SEWAGE DISPOSAL SYSTEM

DEPARTMENT OF HEALTH AND MENTAL HYGIENE

SUBDIVISION Fulton Manor LOT 7 ROAD 12300 Carol Drive

PROPERTY OWNER Gary and Susan Amey

GRADING STUDY

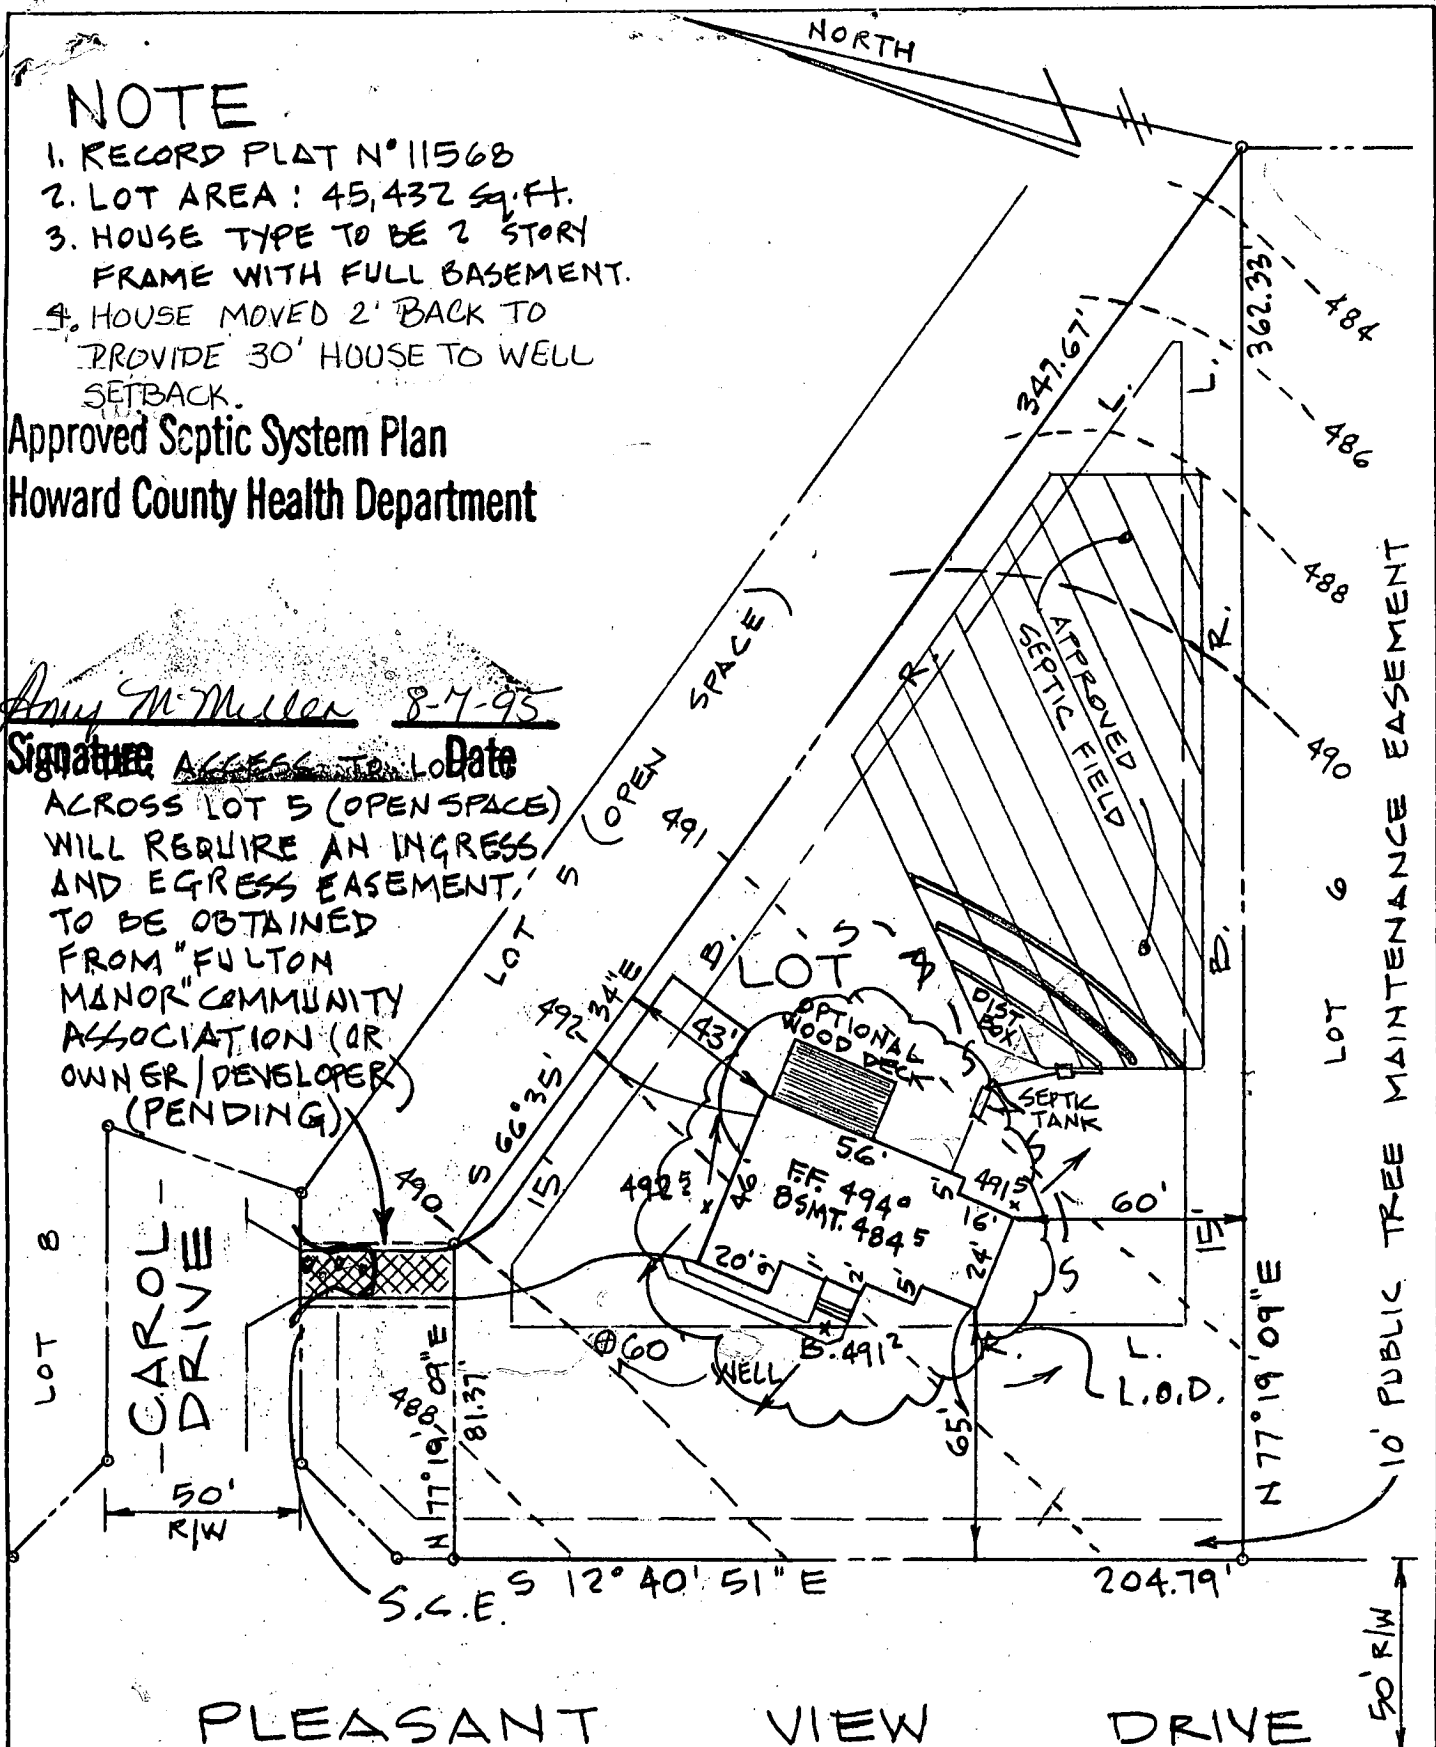
1. RECORD PLAT N° 11568
2. LOT AREA: 45,432 Sq. Ft.
3. HOUSE TYPE TO BE 2 STORY FRAME WITH FULL BASEMENT.
4. HOUSE MOVED 2' BACK TO PROVIDE 30' HOUSE TO WELL SETBACK.

FOOTING & FRAME PLAN scale 1/4" = 1'-0"

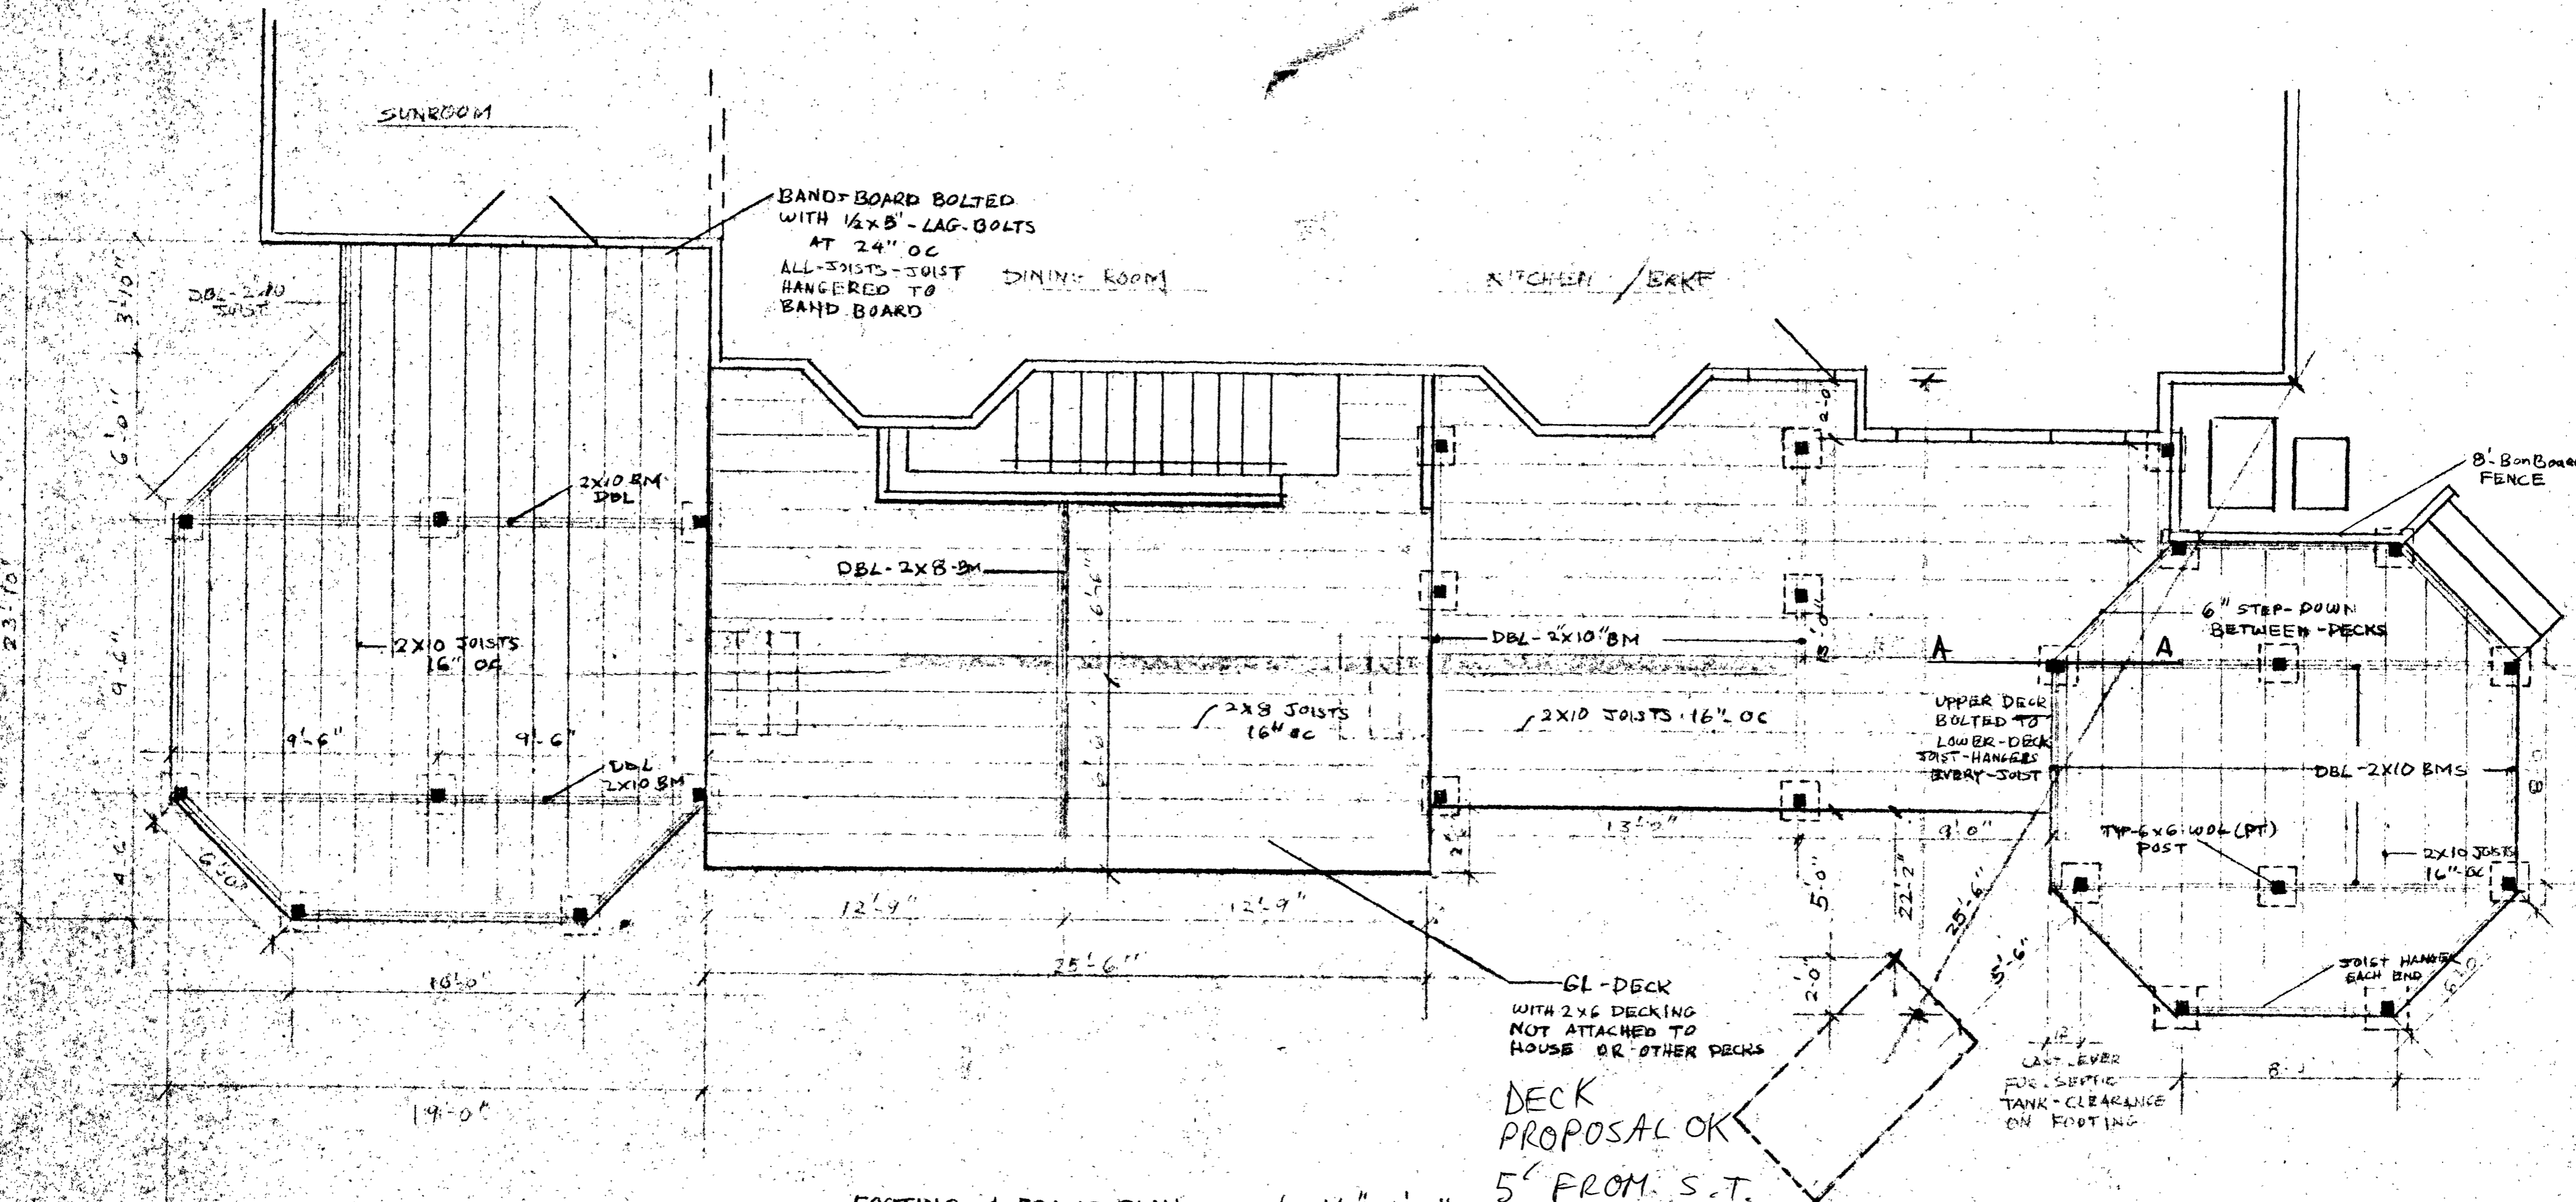
DECK PROPOSAL OK
 5' FROM S.T.
 TO ALL PARTS OF DECK AS PREV.
 AGREED TO MR 8/15/97

LOCATION DIAGRAM

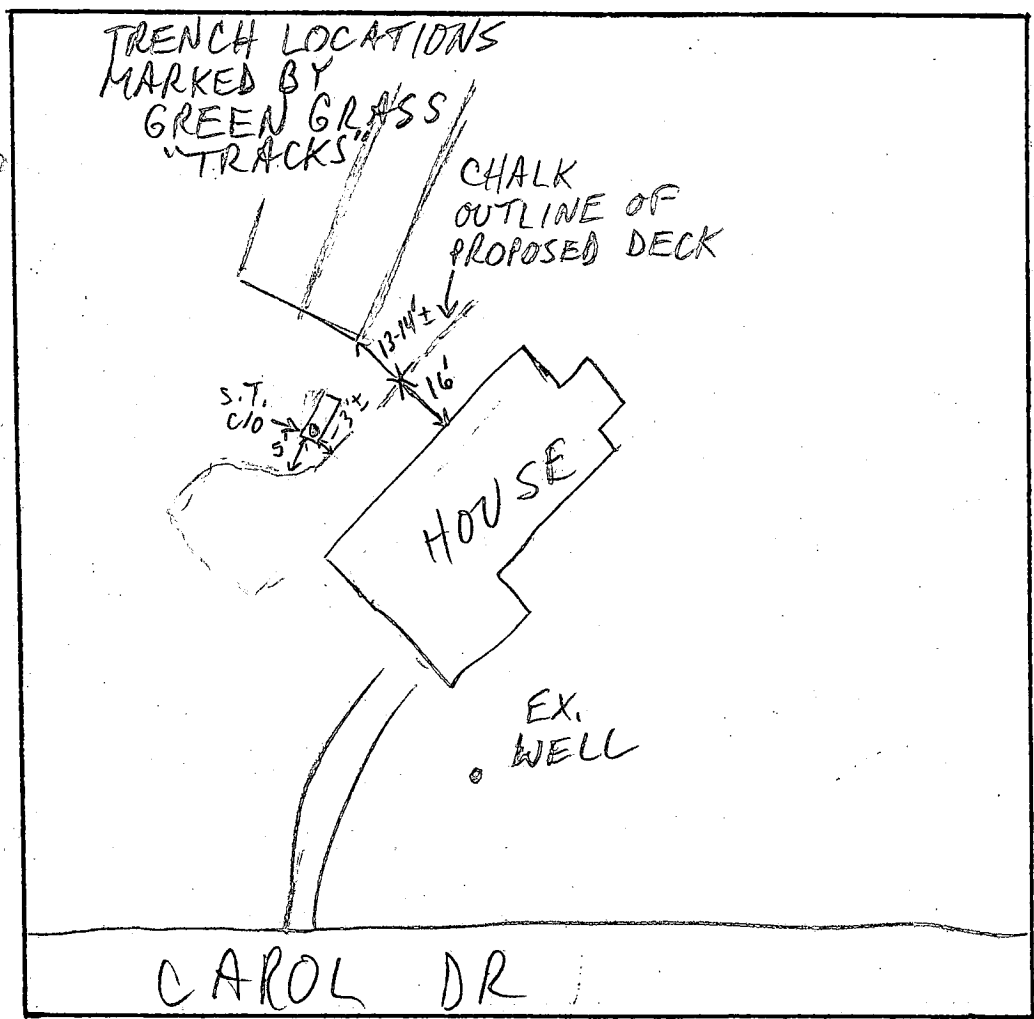
COMMENTS: 7/29/97 PROPOSED DECK 2' TO EX. S.T. - UNACCEPTABLE;
7/31/97 T/C w/OWNER: ALTHO CONCESSION TO 5' SETBACK HAD
ALREADY BEEN GRANTED BY ALM, HE WANTED FURTHER
SETBACK REDUCTION. I ADVISED THAT WAS NOT POSSIBLE
DUE TO SIG. POTENTIAL FOR IMPACT TO S.T., AND REDESIGN
 DATE: _____ INSPECTOR: _____
OR S.T. RELOC. NECESSARY, SIMILAR INFO COMMUNICATED TO
DECK CONTRACTOR SEPARATELY; HE WILL WORK ON SOLUTION MR

PLEASANT VIEW DR
RESOLVED
8/15/97
MR
